PLANNING COMMISSION MEETING

LOCATION: TOWNSHIP ANNEX, 7527 HIGHLAND ROAD, WHITE LAKE, MI 48383
THURSDAY, JUNE 20, 2024 – 6:30 PM

Project Name: West Valley
 Description: Final site plan re-approval
 Date on Agenda this packet pertains to: June 20, 2024

RE: West Valley – Final Site Plan and Final Engineering Plan – 9th Review

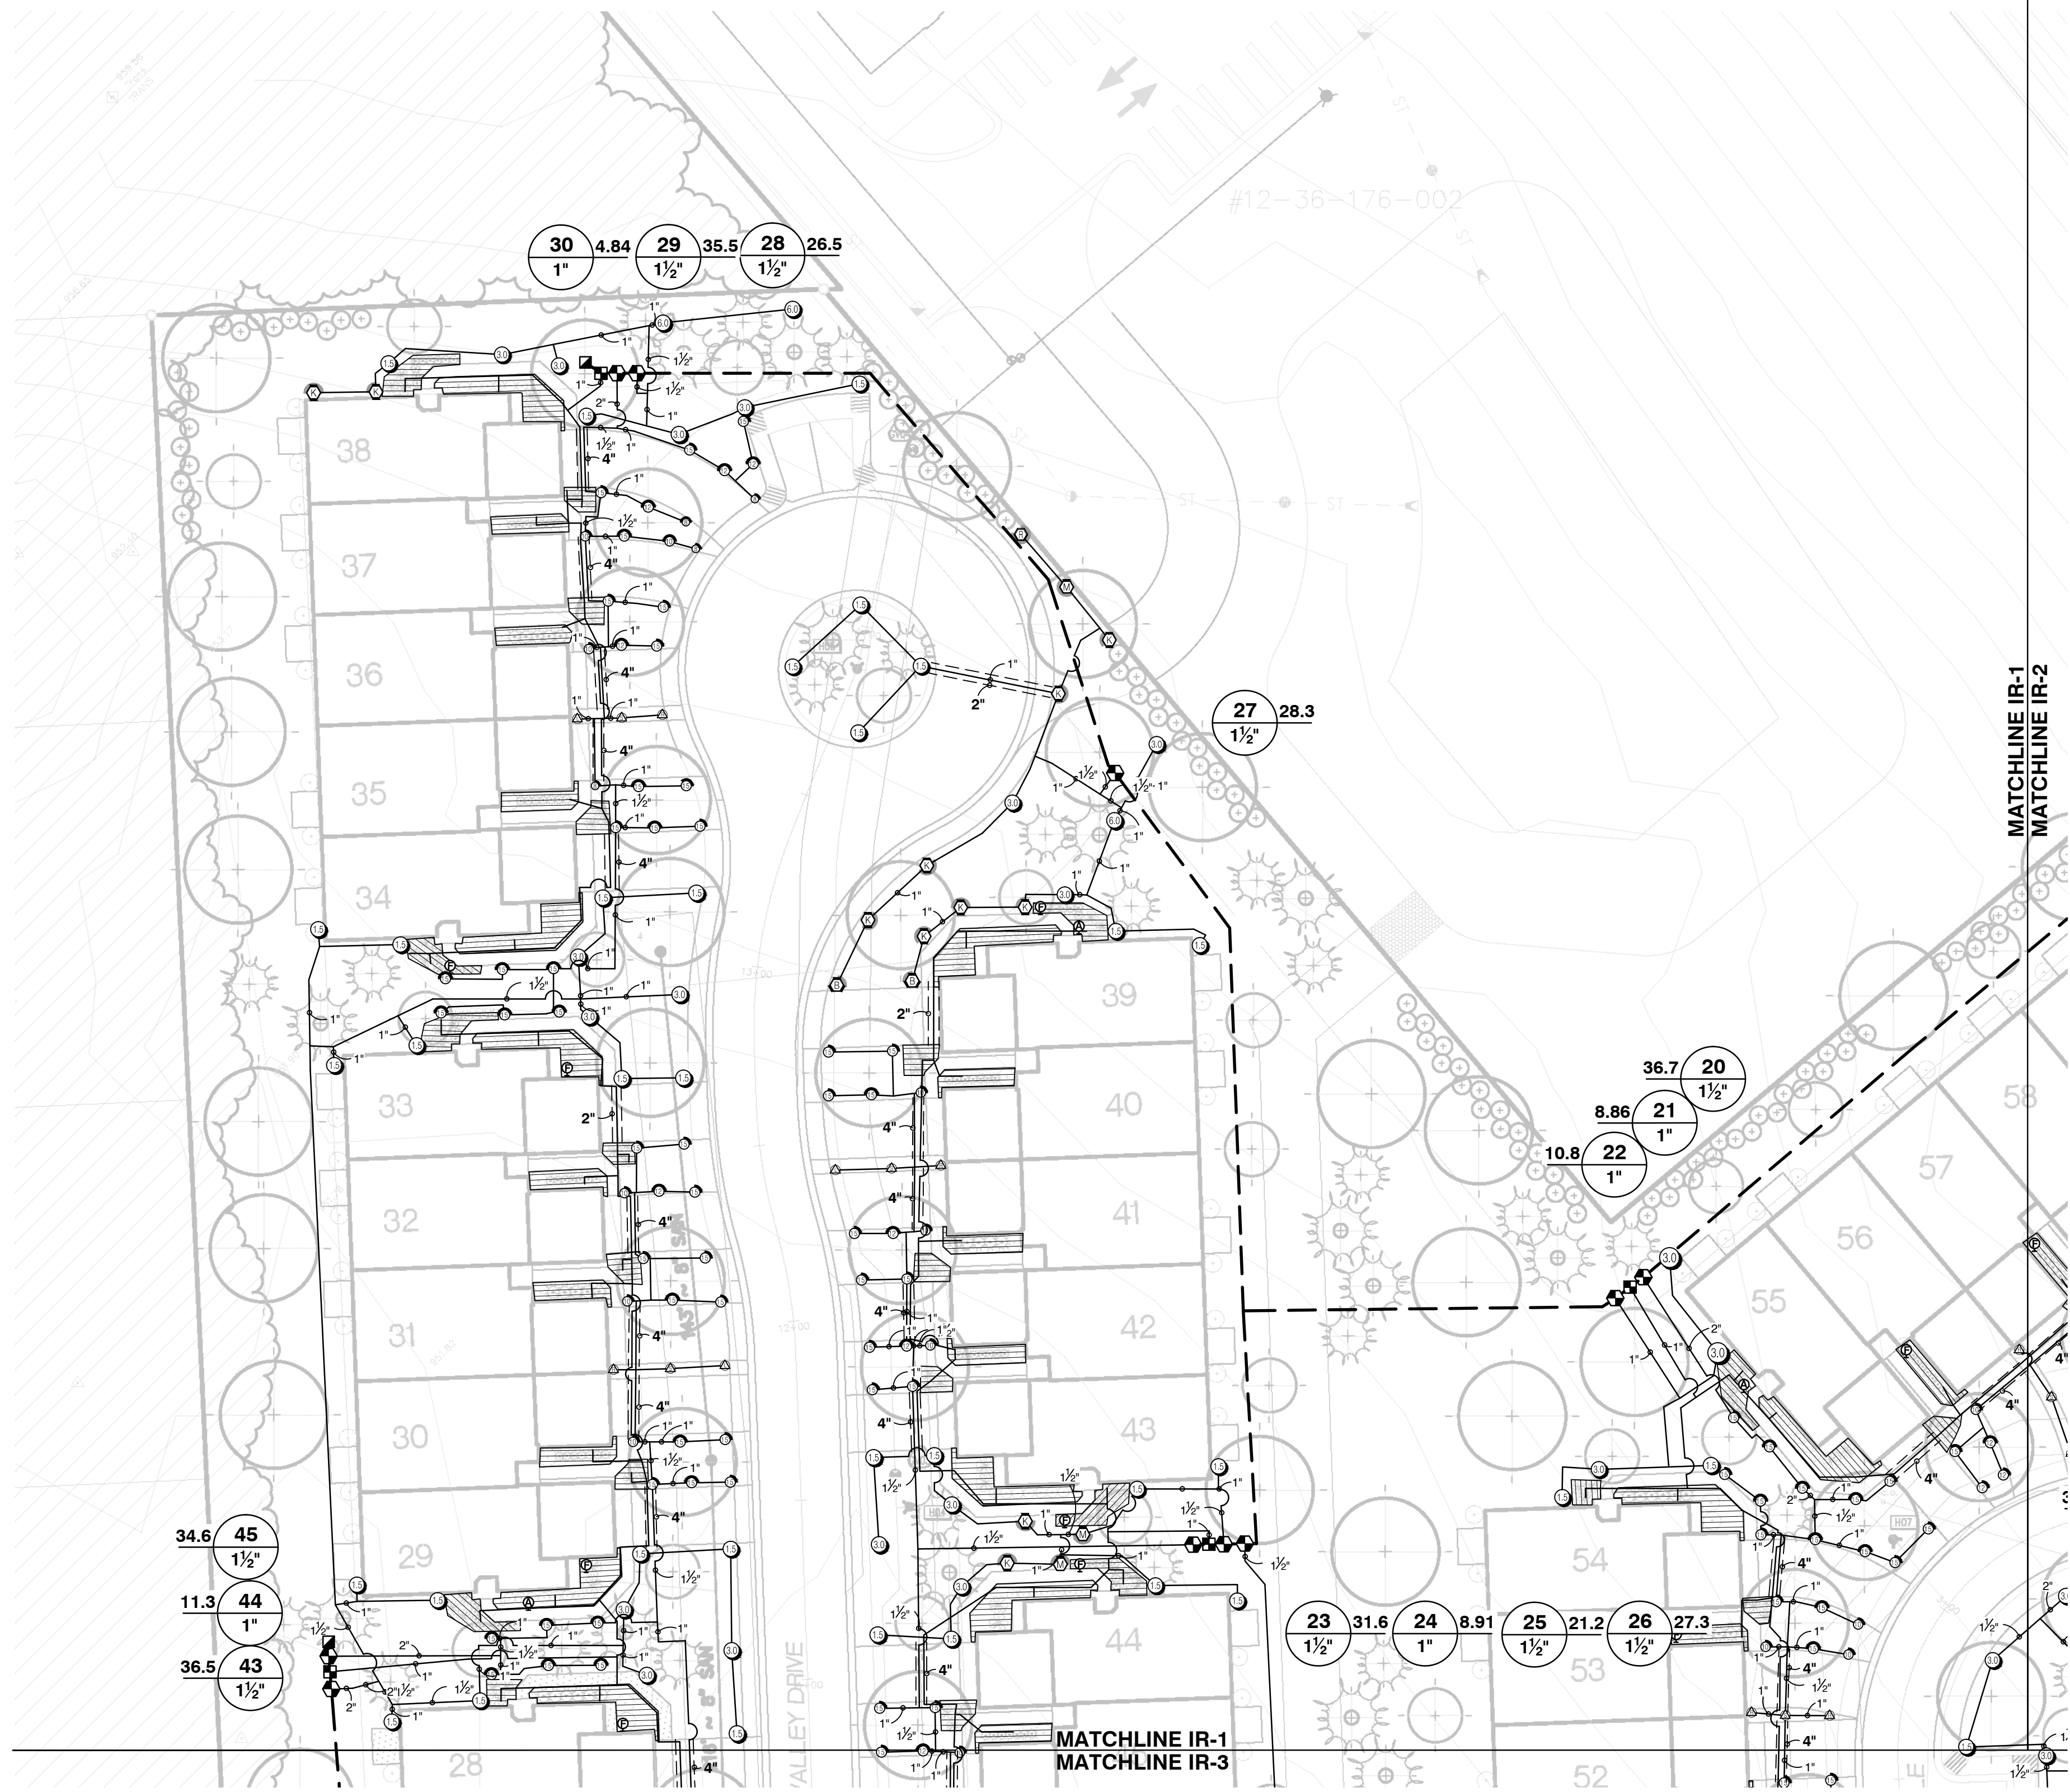
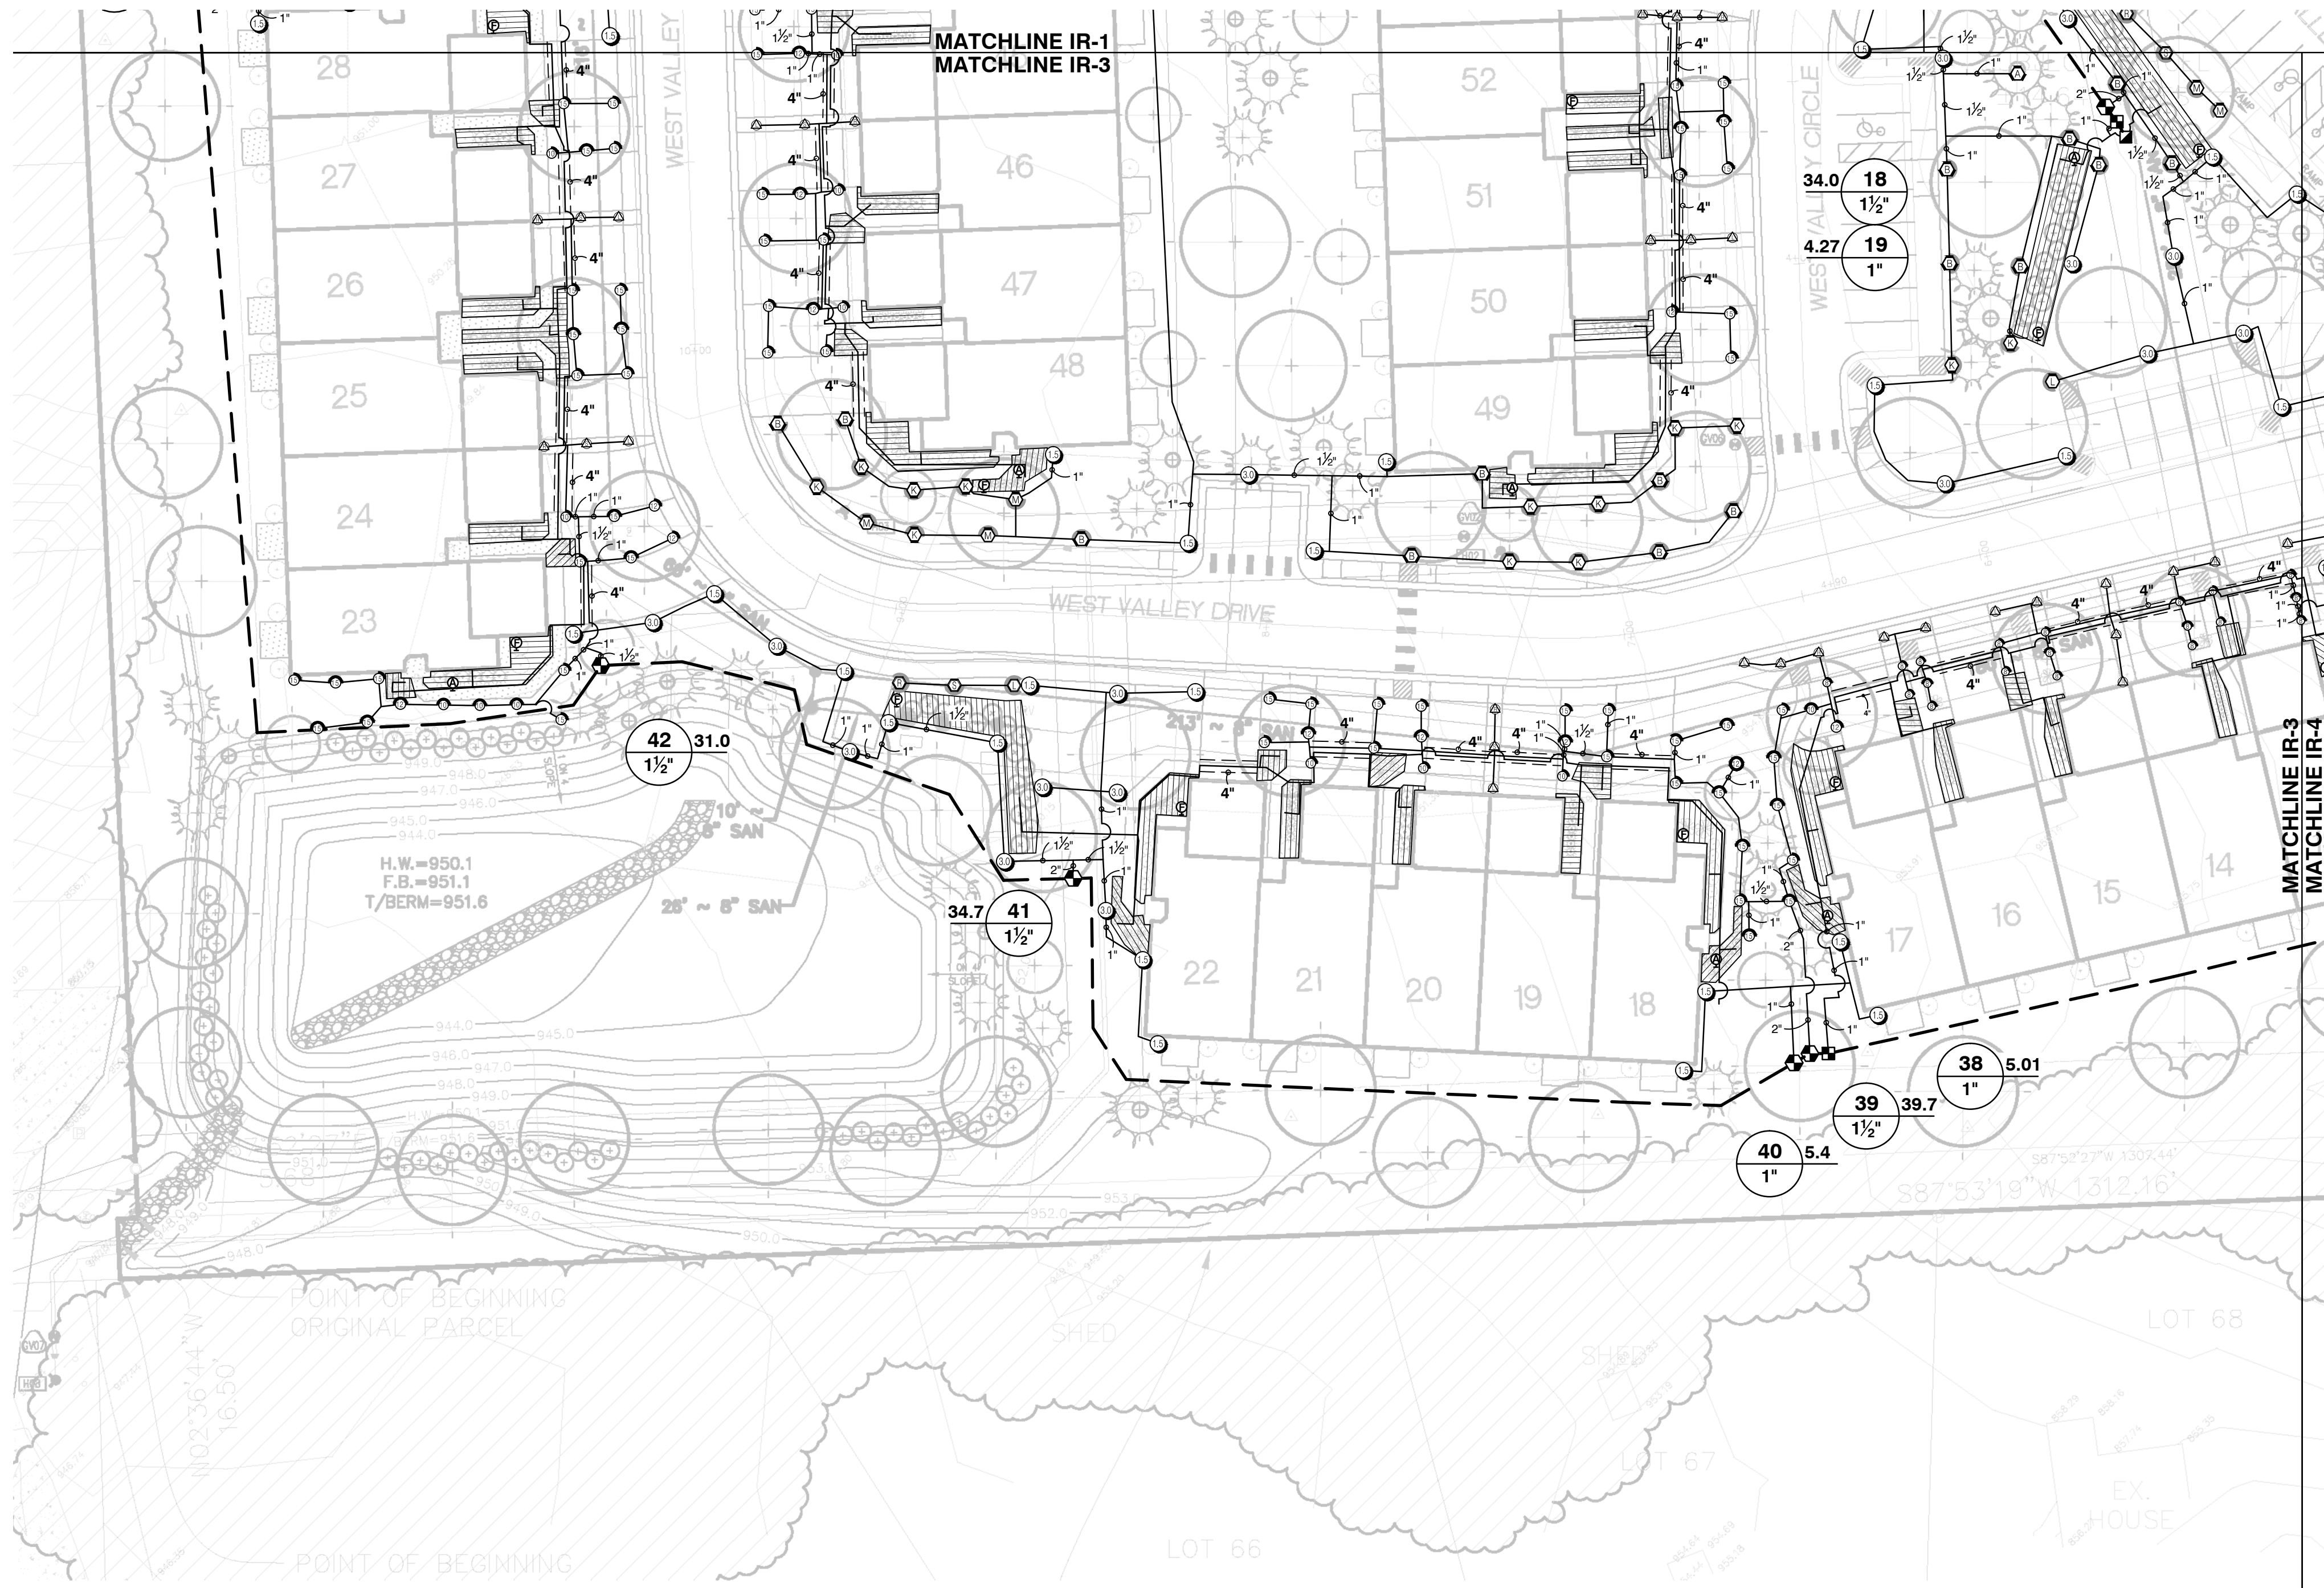
1. Revision dates for Sheets IRR 1 through 6 have been corrected to reflect May 29th, 2024.
2. Sheet LS 5 has a note stating “*All site irrigation systems shall include a rain sensor or similar measure to ensure irrigation down not occur during or shortly after precipitation events.*” It is likely “*down*” is an error and is intended to state “*does*”.
